U.S. Department of Energy
ENERGY STAR Program

Windows, Doors, and Skylights
Revised Draft Criteria and Report

Published: March 11, 2009

Figure 1: Revised Draft ENERGY STAR Climate Zone Map

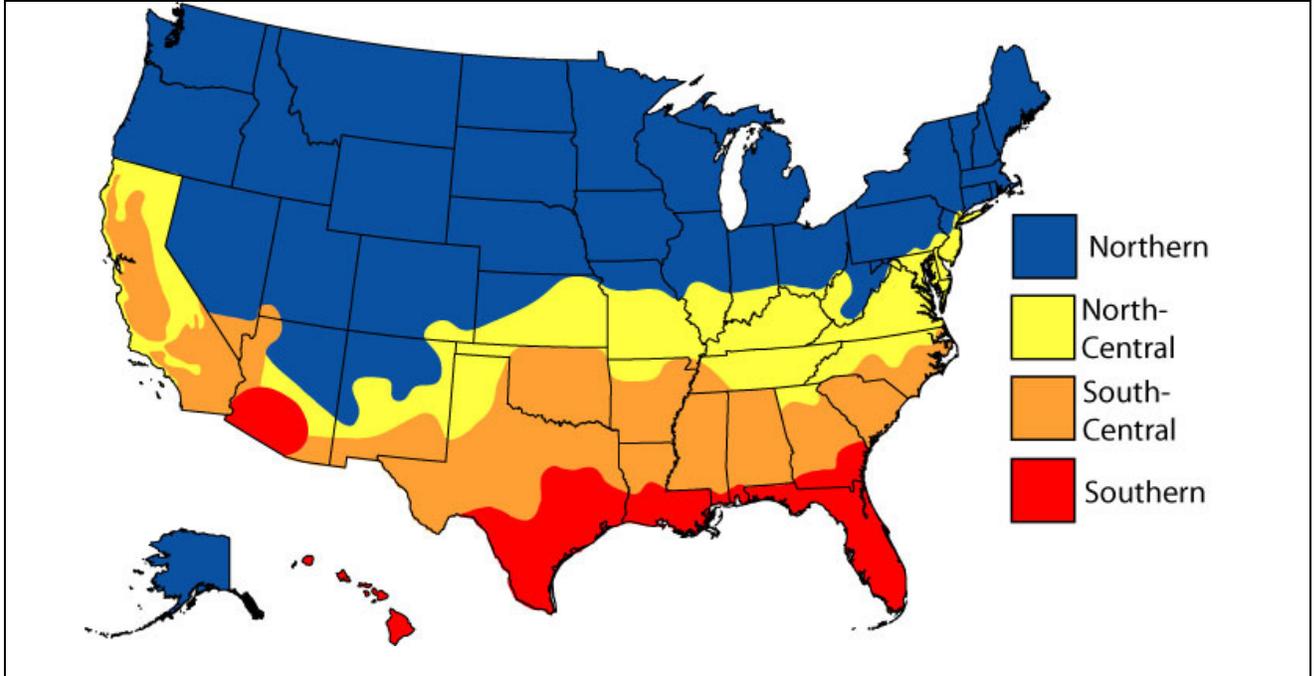
Stakeholders raised several concerns about the map proposed in the *Draft Criteria and Analysis* and suggested solutions:

- The criteria levels proposed in Zones ES5 and ES4 are too similar to warrant separate zones, and additional zones complicate the current four-zone system. The Window and Door Manufacturers Association (WDMA) and the American Architectural Manufacturers Association (AAMA) jointly proposed an alternative map that combined the two zones and ES5a, among other changes.
- The establishment of a “by-request” zone in the Pacific Northwest sets a precedent for the creation of additional zones based on stakeholder request and the introduction of too much complexity for the consumer.
- The use of numeric nomenclature for the climate zones causes confusion with IECC zone numbers. Stakeholders suggested returning to the geographic designations used in the current ENERGY STAR map.

Responding to these stakeholder comments, DOE made the following changes to the ENERGY STAR climate zone map (see Figure 1):

- Combined the proposed Zones ES5 and ES4 into one zone because both zones can benefit from the same criteria;
- Re-integrated Zone ES5a into the standard Northern Zone, as the 0.30 U-factor option now meets the incentive requirements of the NW utilities; and
- Returned zone nomenclature to geographic designations to avoid confusion with IECC zone numbers.
